適航指令發布單

民航局AD編號 AD number	CAA-2026-07-003	發布日期 Date issued	2026/07/02
適用之航空產品 Applied to (models, serial numbers or part numbers, as applicable)	This AD applies to all The Boeing Company Model 737-100, -200, -200C, -300, -400, -500, -600, -700, -700C, -800, -900, and -900ER series airplanes, certificated in any category, except for Model 737-200 and -200C series airplanes equipped with an SP-77 flight control system.		
主旨摘要 Subject	This AD requires revising the existing airplane flight manual (AFM) to incorporate limitations prohibiting certain operations requiring radio altimeter data when operating in Canadian airspace.		
民航局 CAA	設計國民航主管機構 Original Authority		
<input type="radio"/> 本國產品 Native product	<input checked="" type="radio"/> FAA <input type="radio"/> Germany LBA <input type="radio"/> EASA <input type="radio"/> CAA-NL <input type="radio"/> Brazil <input type="radio"/> UK CAA <input type="radio"/> Transport Canada Civil Aviation <input type="radio"/> Japan CAB <input type="radio"/> DGAC <input type="radio"/> CAA of Israel <input type="radio"/> Other_____

[Docket No. FAA-2026-7204; Project Identifier AD-2026-00548-T; Amendment 39-23396; AD 2026-13-13]

Airworthiness Direc

Figure 1 to Paragraph (g)(1)(i)—Fundamental Effective Isotropic PSD at Outside Interface of Aircraft Antenna

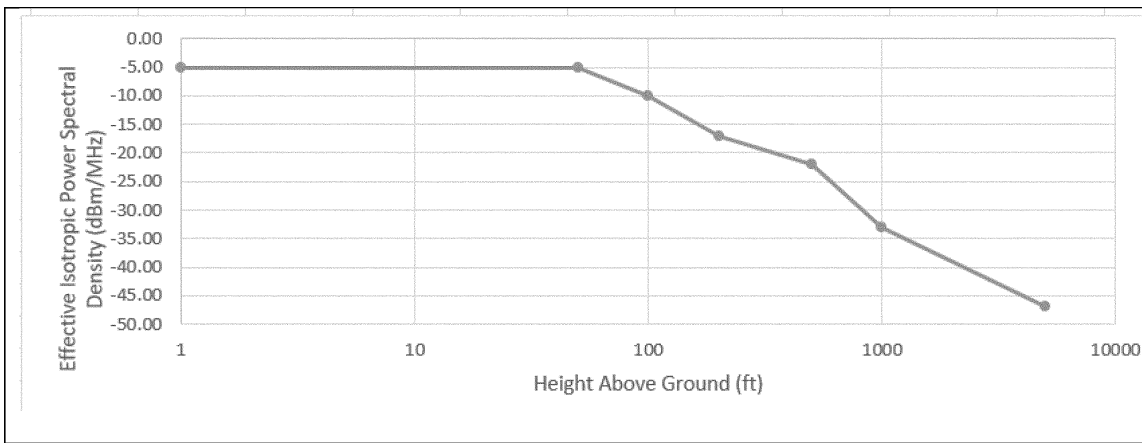
(i) Tolerance to radio altimeter interference, for the fundamental emissions (3.7-3.98 GHz), at or above the power spectral density (PSD) curve threshold specified in figure 1 to paragraph (g)(1)(i) of this AD.

Figure 2 to Paragraph (g)(1)(ii)—Spurious Effective Isotropic PSD at Outside Interface of Aircraft Antenna

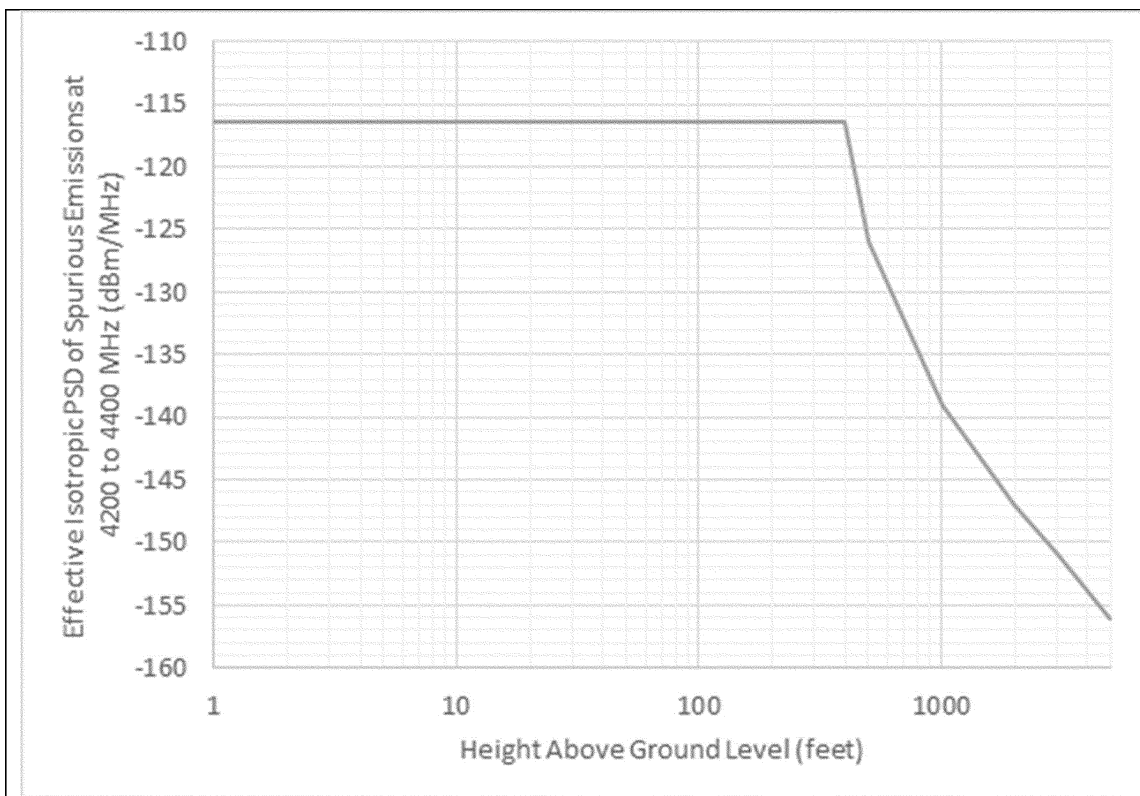
(ii) Tolerance to radio altimeter interference, for the spurious emissions (4.2-4.4 GHz), at or above the PSD curve threshold specified in figure 2 to paragraph (g)(1)(ii) of this AD.
